UNITED STATES PATENT AND TRADEMARK OFFICE

APPLICATION NO.	FILING DATE	FIRST NAMED INVENTOR	ATTORNEY DOCKET NO.	CONFIRMATION NO.
10/807,437	03/24/2004	Ho-Woo Park	SEC.1135	4263
20987	7590	09/06/2005	EXAMINER	
VOLENTINE FRANCO, & WHITT PLLC ONE FREEDOM SQUARE 11951 FREEDOM DRIVE SUITE 1260 RESTON, VA 20190			THOMAS, TONIAE M	
			ART UNIT	PAPER NUMBER
			2822

Office Action Summary

DETAILED ACTION

**FIG. 5**

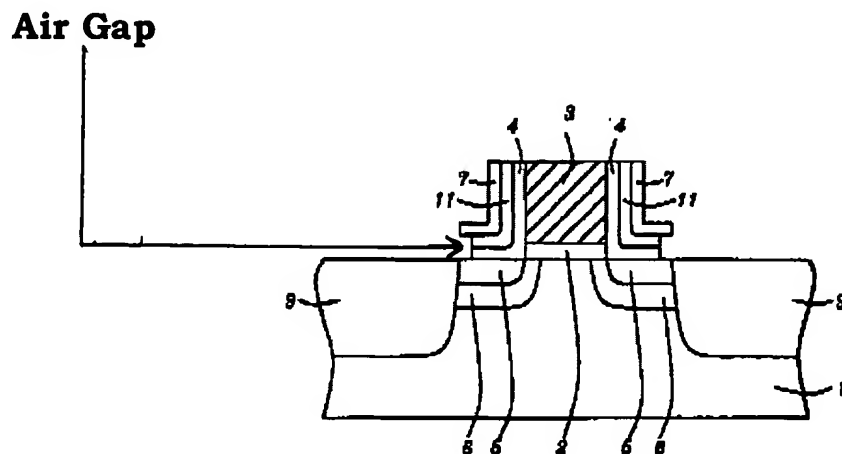
Quek discloses a semiconductor device (see figs. 1-6 and accompanying text). The device comprises: a semiconductor substrate 1 having source/drain regions 9 spaced from each other (see fig. 5 and col. 4, lines 14-17); a gate

pattern 3 disposed on the semiconductor substrate between the source/drain regions (see fig. 5 and col. 3, lines 15-18); L-shaped spacers 7 each including a vertical portion covering a respective one of the side walls of the gate pattern, and a lateral portion extending laterally from the bottom of the vertical portion over a respective one of the source/drain regions (see fig. 5 and col. 4, lines 4-14); and support portions 11 interposed between the L-shaped spacers 7 and the gate pattern 3 (see fig. 5 and col. 3, lines 58-63), the support portions supporting the L-shaped spacers such that the lateral portion of each of the L-shaped spacers is spaced above the source/drain regions 9 over which the lateral portion of the L-shaped spacer extends, and wherein an air gap exists between the lateral portion of each of the L-shaped spacers and the source/drain region over which the lateral portion extends (see fig. 5 and col. 4, lines 42-49).

The source/drain region 9 comprises a lightly doped source/drain region 5 over which the lateral portion of one of the L-shaped spacers extends (see fig. 5 and col. 3, lines 40-44), and a highly doped source/drain region 9 disposed laterally of the lateral portion of the L-shaped spacer 7 (see fig. 5 and col. 4, lines 14-17).

A buffer insulating layer 4 is interposed between the gate pattern and the support portion (see fig. 5 and col. 3, lines 26-29).

Quek does not teach that the L-shaped spacers 7 comprise an oxide layer, as recited in claim 3, or that the support portions 11 comprise a polysilicon layer or a nitride layer, as recited in claim 4. On the contrary the L-shaped spacers comprise a nitride layer (col. 4, lines 4-14), and the support portions comprise an oxide layer (col. 3, lines 58-63).

An etching process is used to form the structure shown in fig. 5. To form this structure, it is essential that the materials used for the spacers 8, the L-shaped spacers 7, and the support portions 11 are chosen so that adjacent layers have different etching rates with respect to one another. For example, the material used for the spacers 8 is silicon oxide, while the material used for the L-shaped spacers 7, which are adjacent to the spacers 8, is silicon nitride. Likewise, silicon oxide is the material used for the support portions 11, which

are adjacent to the L-shaped spacers 7. Alternating layers of silicon nitride and silicon oxide are used for the spacers 8, the L-shaped spacers 7, and the support portions 11 because silicon oxide and silicon nitride have different etching rates with respect to one another. Since silicon oxide and silicon nitride have different etching rates with respect to one another, using a nitride layer for the oxide spacers 8, an oxide layer for the L-shaped spacers 7, and a nitride layer for the support portions 11 is an obvious modification of Quek. In addition, because polysilicon and silicon oxide have different etching rates with respect to one another, it would have been obvious to the skilled artisan, at the time the invention was made, to use polysilicon in place of silicon nitride.
